Patent No.: 5,854,893

For: SYSTEM FOR TELECONFERENCING IN WHICH COLLABORATION TYPES AND PARTICIPANTS BY NAMES OR ICONS ARE SELECTED BY A PARTICIPANT OF THE TELECONFERENCE

REQUEST FOR CERTIFICATE OF CORRECTION OF PATENT

Drawings:

FIGURE 12A

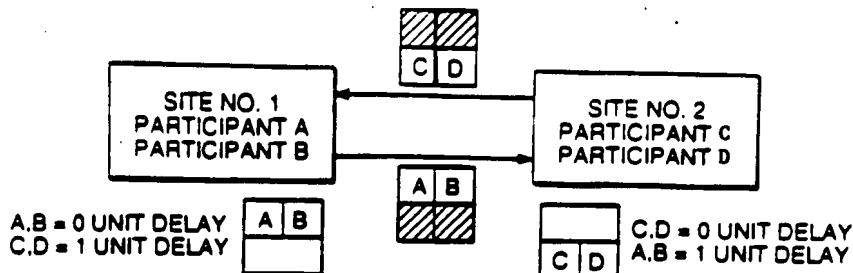
In the drawings, Sheet 10, Figure 12A, in the first square block at the top, a solid vertical line should separate "C" and "D" and divide the block in half; please see attached Figure 12A. *a*

Also in Figure 12A, in the square block below the block described above, a solid vertical line should separate "A" and "B" and divide the block in half; please see attached Figure 12A. *a*

Also in Figure 12A, in the first box on the right, indicated by "SITE NO. 2" the line reading "PARTICIPANT A" should read - -PARTICIPANT C- -; *a*

Also in the same box, the line reading "PARTICIPANT B" should read - -PARTICIPANT D- -; *a*

FIGURE 12B

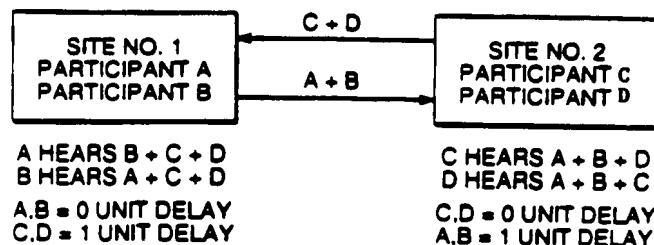
In the drawings, Sheet 10, Figure 12B, in the first box on the right, indicated by "SITE NO. 2" the line reading "PARTICIPANT A" should read - -PARTICIPANT C- -; also in the same box, the line reading "PARTICIPANT B" should read - -PARTICIPANT D- -; please see attached Figure 12B. *a*

FIGURE 13B

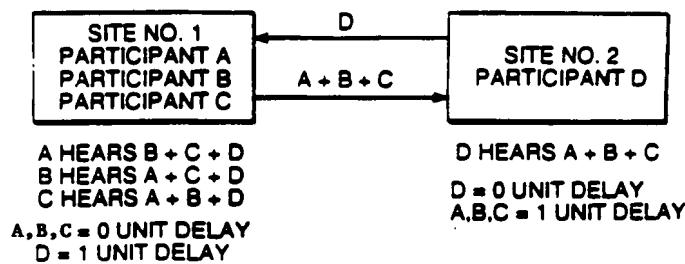
In the drawings, Sheet 10, Figure 13B, the line reading "A,B = 0 UNIT DELAY" should read - -A,B,C = 0 UNIT DELAY- -; please see attached Figure 13B. *a*

FIGURE 14B

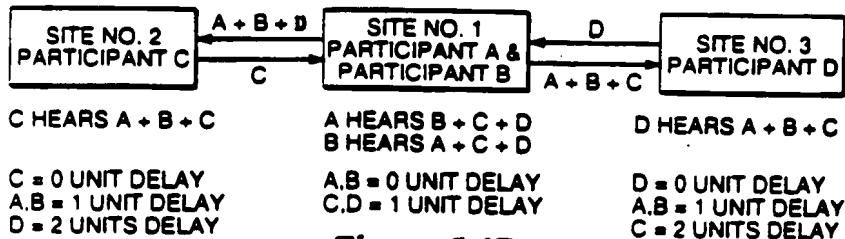
In the drawings, Sheet 11, Figure 14B, the description above the arrow pointing from the middle box to the left box reading "A + B + C" should read - -A + B + D- -; please see attached Figure 14B. Also in Figure 14B, the line below the left box reading "C HEARS A + B + C" should read - -C HEARS A + B + D- -; please see attached Figure 14B. *a*

FIGURE 15A

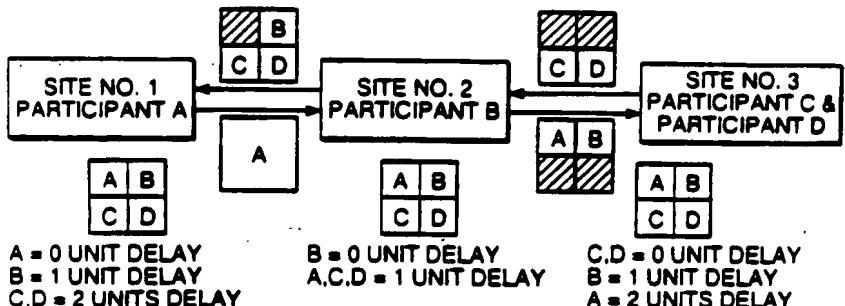
In the drawings, Sheet 11, Figure 15A, in the two square blocks between the middle rectangular block and the right rectangular block, there should be vertical lines in the shaded areas dividing the blocks in half; please see attached Figure 15A. *a*

*FIGURE 16*

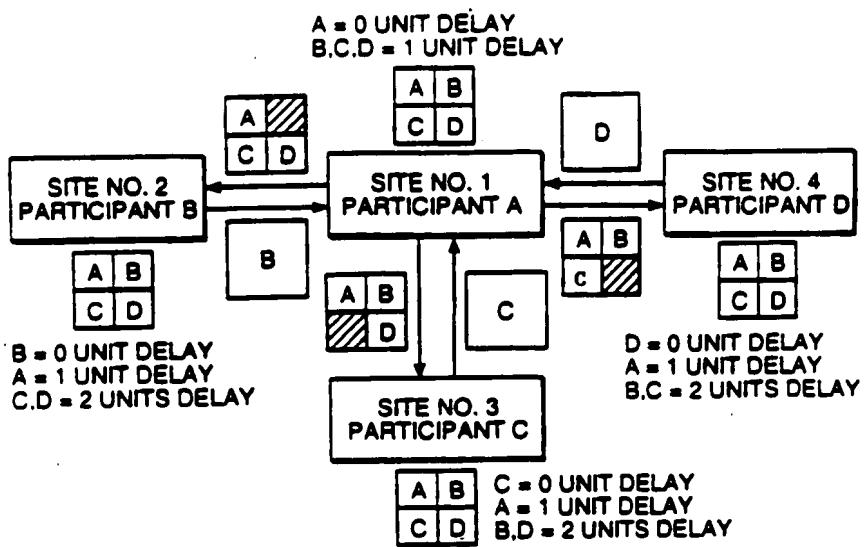
In the drawings, Sheet 12, Figure 16, in the square block below the arrow pointing from the top middle rectangular block to the right rectangular block, the lower-left reference reading "D" should read - -C- -; please see attached Figure 16. *a*

FIGURE 17A

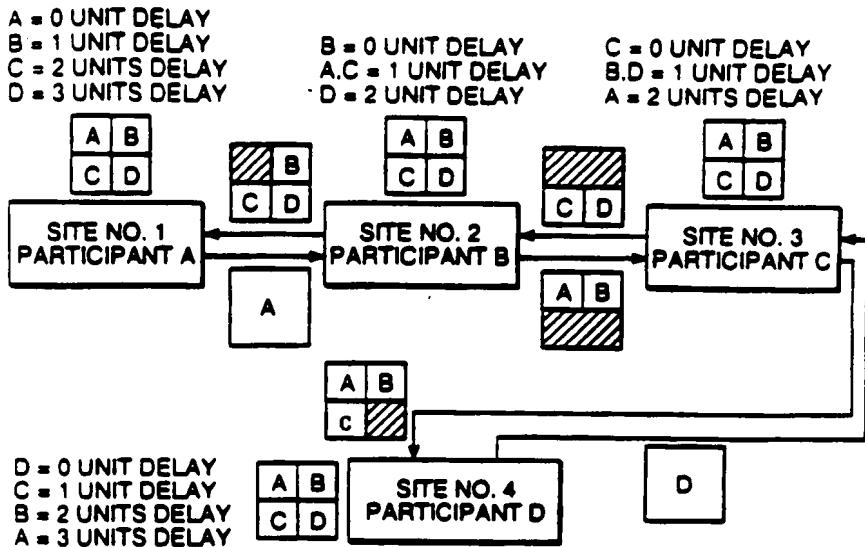
In the drawings, Sheet 13, Figure 17A, in the square block just above the lowest rectangular block, the lower-left reference reading "D" should read - -C- -; please see attached Figure 17A. *a*

FIGURE 17B

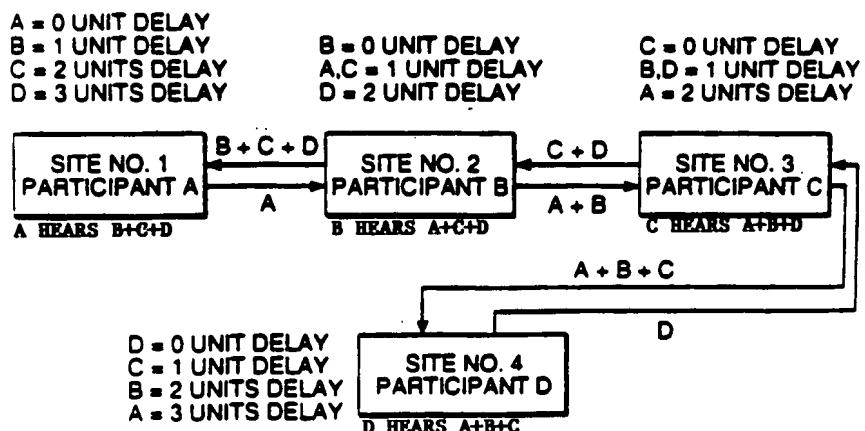
In the drawings, Sheet 13, Figure 17B, below the top left rectangular block, insert  
- -A HEARS B + C + D- -; also in Figure 17B, below the top middle rectangular block, insert  
- -B HEARS A + C + D- -; also in Figure 17B, below the top right rectangular block, insert  
- -C HEARS A + B + D- -; also in Figure 17B, below the bottom middle rectangular block, insert - -D HEARS A + B + C- -; please see attached Figure 17B. *a*
